CITY OF ALBUQUERQUE

Re: Clean Machine Car Wash
6016 Central Ave. SE
Traffic Circulation Layout
Engineer's/Architect's Stamp 09-15-16 (K18-D079)

Based upon the information provided in your submittal received 09-15-16, the above referenced plan cannot be approved for Building Permit until the following comments are addressed:

SITE PLAN

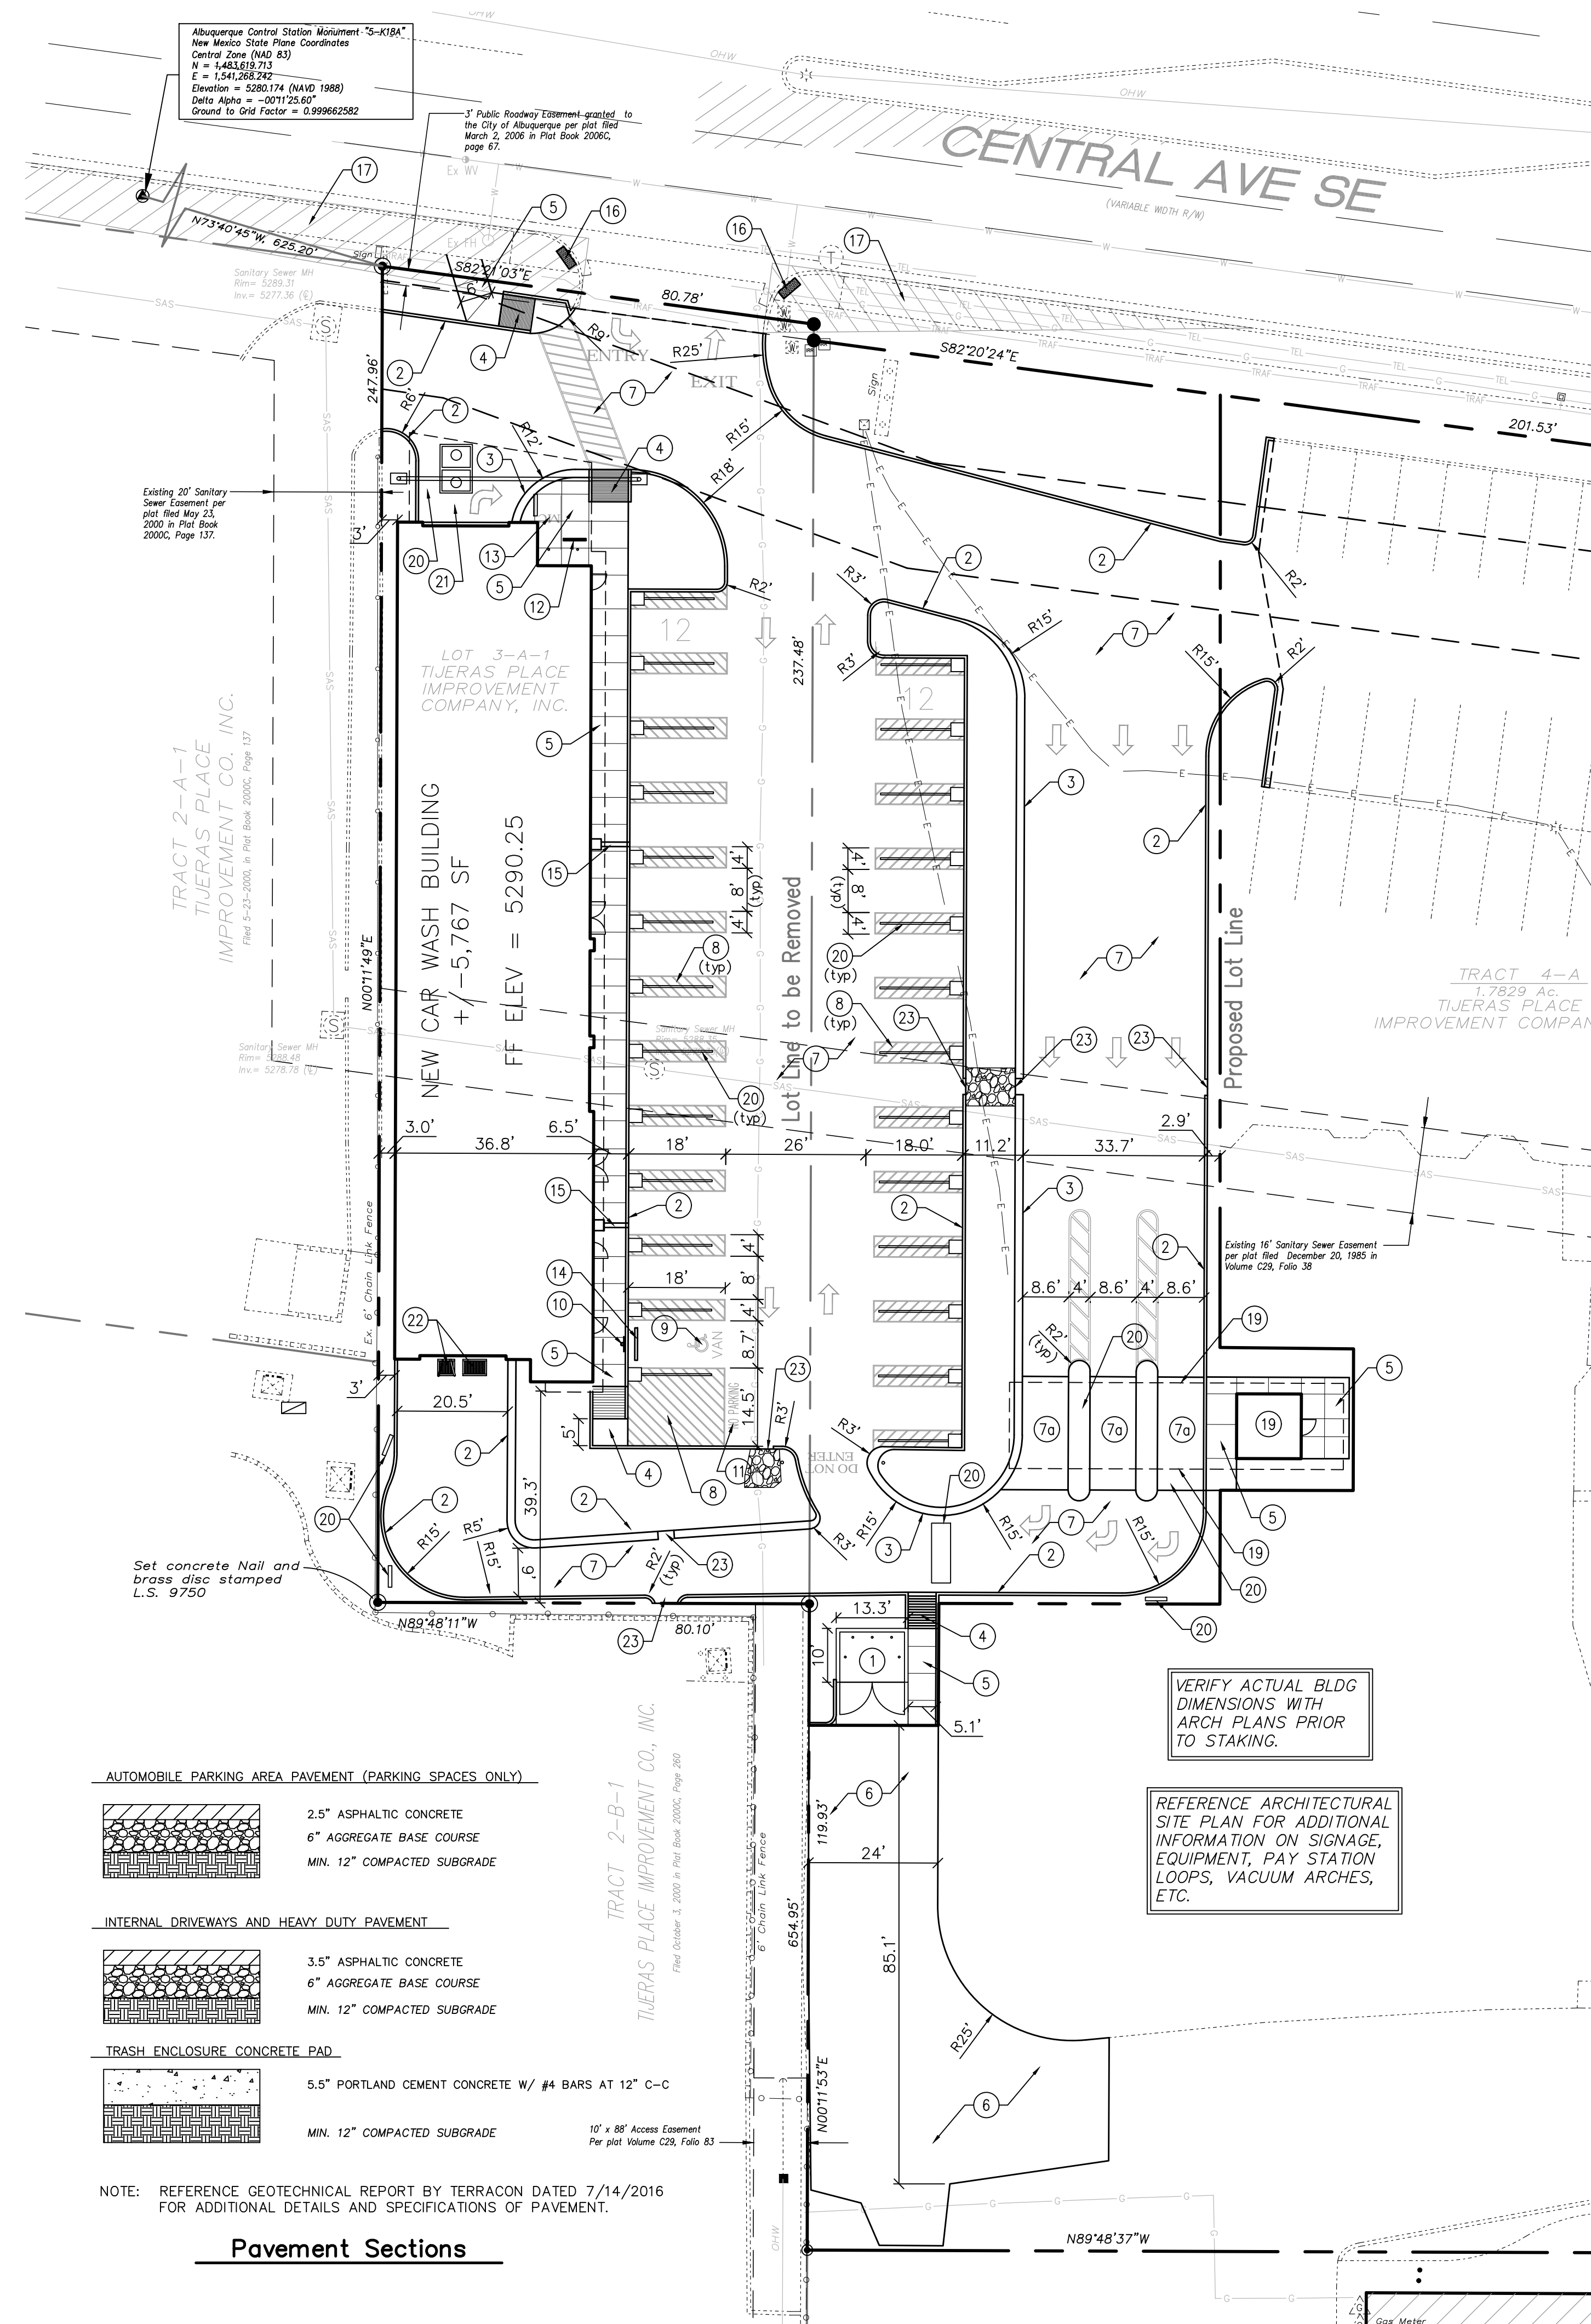
1. Identify all existing access easements and rights of way width dimensions.
2. Identify the right of way width, medians, curb cuts, and street widths on Central.

3. Clarify existing property lines and proposed property lines.
 - DRB approval is required for proposed lot line and removal.
 - Provide shared access/access agreements for the refuse, J.D. Byrider entrance, and parking lot locations.

4. Show all drive aisle widths and radii. Some dimensions are not shown. Minimum lane widths are 12 feet minimum with a 25 foot minimum radius (inside edge) for all turns. (A 15 foot radius can be used with an increase in lane width to 14 feet).

5. A 5 ft. keyway is required for dead-end parking aisles.
6. Per the zoning code, a 6 ft. wide ADA accessible pedestrian pathway is required from the public sidewalk to the building entrances. Please provide details and dimensions.

7. Provide a min 6" or max 8" high concrete barrier curb or other acceptable barrier between landscaping and parking areas and/or drive aisles. Please call out detail and location of barrier curb. Parking areas shall have barriers which prevent vehicle encroachment and which shall be located two feet from any pedestrian walkway or landscaped area.

8. Service vehicle and/or refuse vehicle maneuvering must be contained on-site; provide a copy of refuse approval.
9. One-way vehicular paths require pavement directional signage. Please show detail and location of posted signs.

10. Work within the public right of way requires a work order with DRC approved plans.
11. Pedestrian path in front of building will need to be eight (8) feet per zoning code.
